**Stage 1 Quality Audit Report  
Social Housing Bundle 4,  
Development at Church of the  
Annunciation, Finglas, Dublin City  
Council**

<b>Client:</b>	Malone O'Regan Consulting Engineers
<b>Document No:</b>	231860-ORS-XX-XX-RP-TR-13g-004

### Location: Southwestern Site Boundary

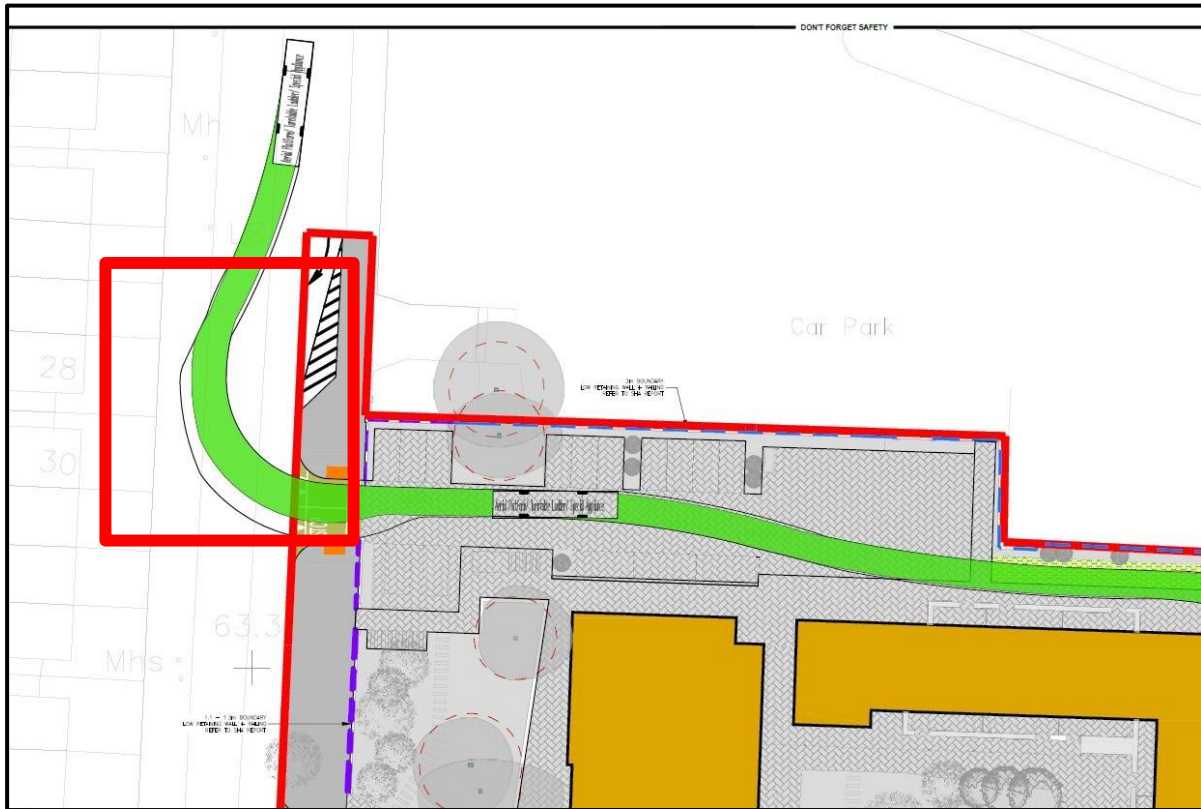
The audit team note from the drawings that there is a new uncontrolled crossing proposed at the southwestern corner of the site boundary. However, it is not evident from the provided drawings whether the necessary dropped kerbing is incorporated to enable users to access both sides of the footpath. The team expresses concern that wheelchair users may encounter difficulties accessing the footpath, potentially resorting to using the road to reach the nearest dropped kerb, thereby risking collisions between vehicles and pedestrians.

The design team should ensure that details and locations of dropped kerbs, connecting footpaths as well as tactile paving are provided for.

**Location: Area Identified**

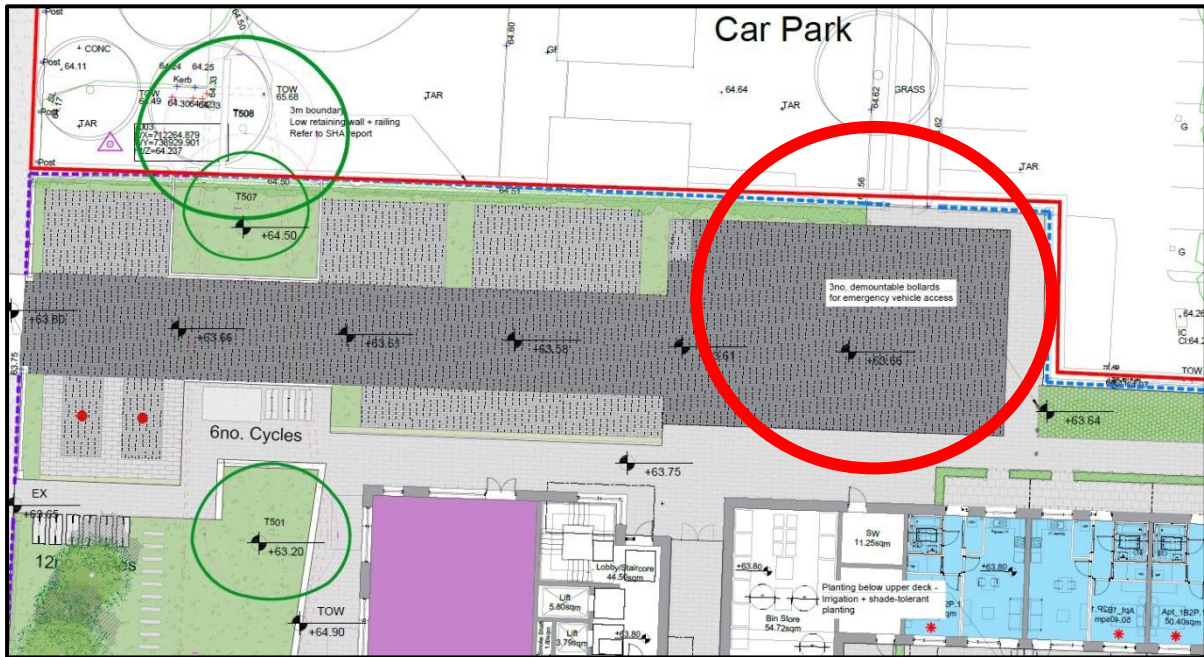
The audit team note from the plans provided that there is a large open area identified below next to the proposed carpark area which could result in illegal parking. This could potentially result in an increased risk of vehicle conflict which could result in injury.

The design team should incorporate measures at the area identified, such as a hammerhead to facilitate turning vehicles within the development.

**Location: Gated Access Point for Emergency Vehicles**

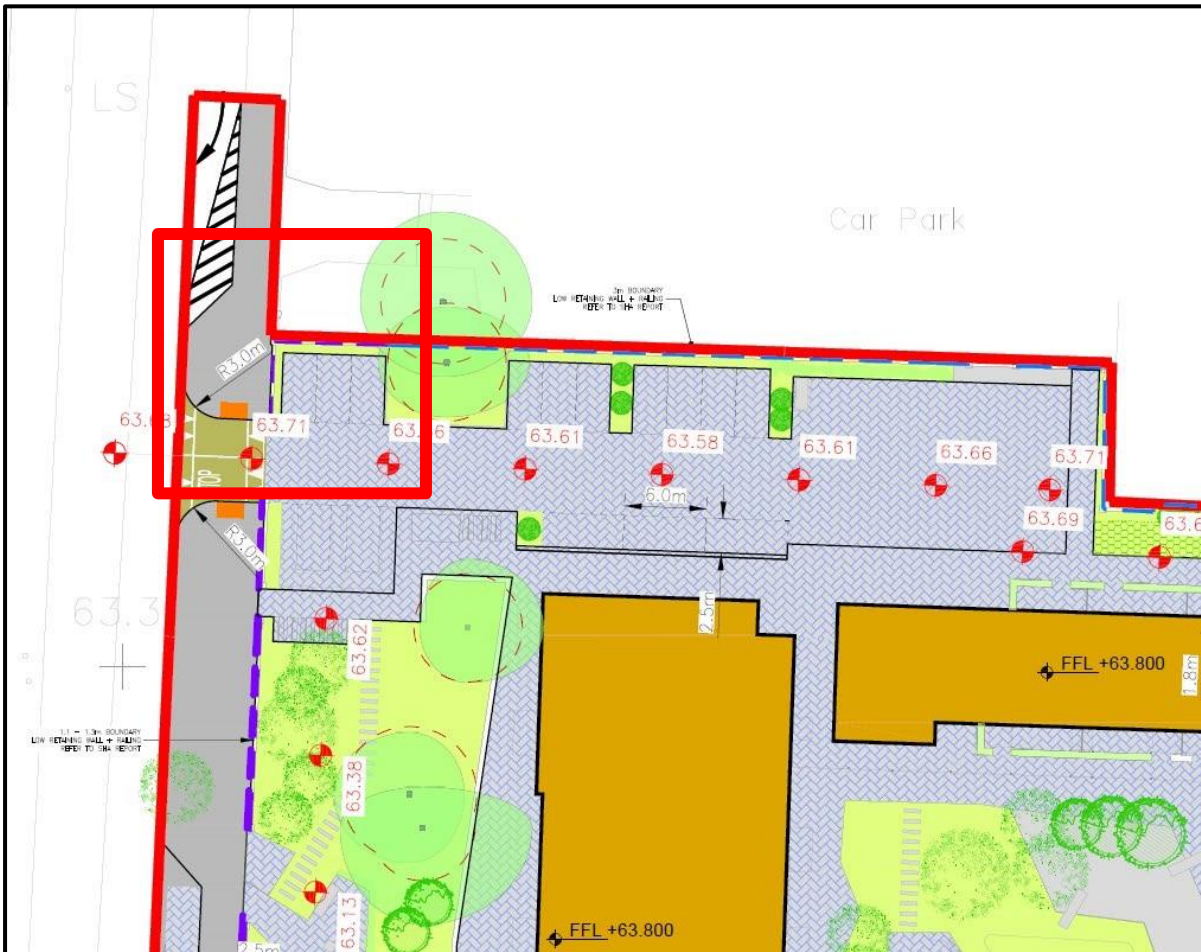
The audit team note from the plans that while adequate sightlines are initially provided for emergency vehicle access, concerns arise due to the presence of existing trees that are being retained and the proposed addition of another tree near the on-street parking spaces. These trees could potentially hinder visibility if they become overgrown. Inadequate visibility splays for emergency vehicles pose a significant risk, potentially leading to side impact or rear-end shunt-type vehicle collisions, resulting in injuries.

The design team should carefully assess the proposed landscaping plans to ensure that the type and placement of trees does not compromise visibility for emergency vehicles. If necessary, consider relocating or adjusting the placement of trees to maintain adequate sightlines.
